CITY OF ALBUQUERQUE

RE: **Lot 33 Block 6 Unit 18 SAD 228
6601 Sujeto Rd. NW
Volcano Cliffs Subdivision
Revised Grading and Drainage Plan
Engineers Stamp Date 7/26/2021 (D10D003M33)**

DRAINAGE AND TRANSPORTATION INFORMATION SHEET (REV 6/2018)

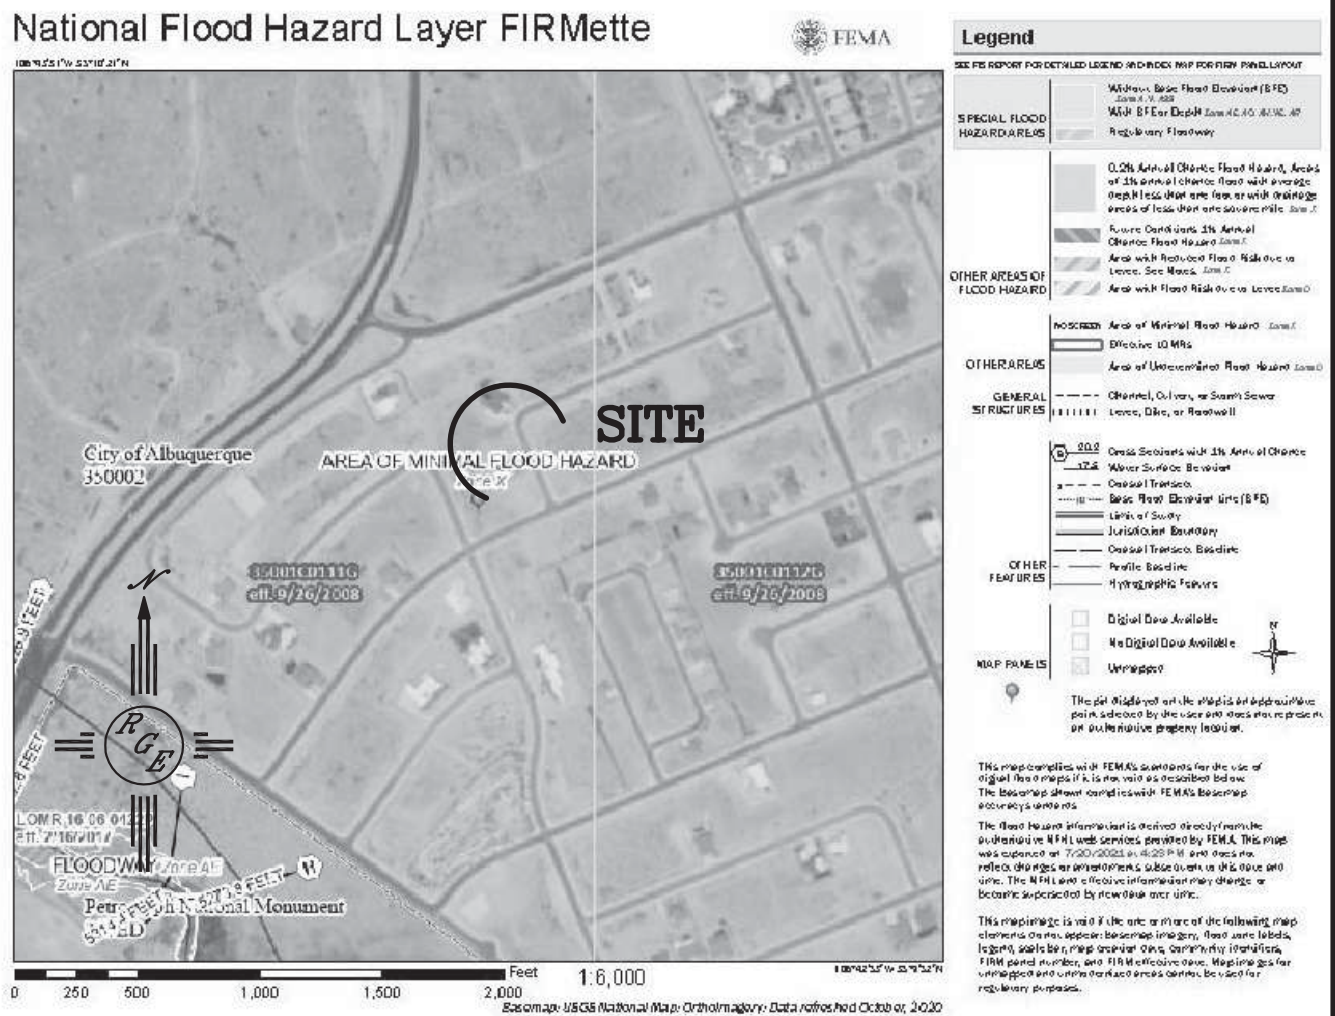
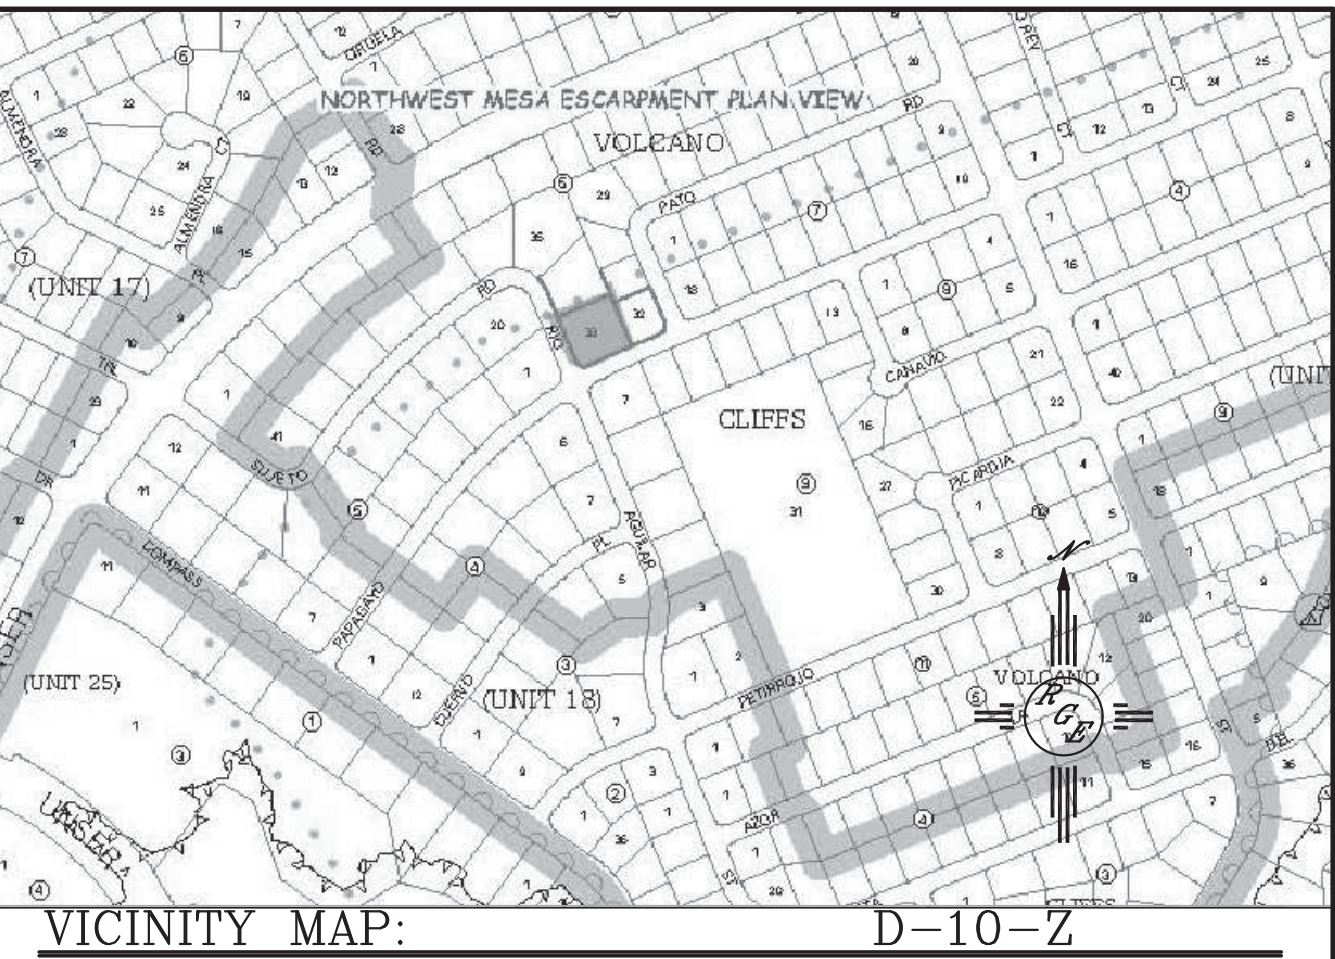
PO Box 1293
Based upon the information provided in your submittal received 7/27/2021, this plan is approved for Grading Permit. This will now be the plan used going forward.

Albuquerque
Prior to Building permit approval a Pad Certification will be required, provided by the Engineer or a registered Land Surveyor.

NM 87103
Advise the owner contractor not to use dirt as a ramp to climb the curb, use lumber or crusher fines for this purpose.

www.cabq.gov
Reiterate to the Owner/Contractor that a separate permit for a garden/retaining wall must be obtained with the approved G&D plan and Pad Certification. Also, if a swimming pool is to be placed after this approval a new grading and drainage plan will need to be resubmitted showing the changes for the land treatments.

Prior to Certificate of Occupancy release, Engineer Certification per the DPM checklist is required.
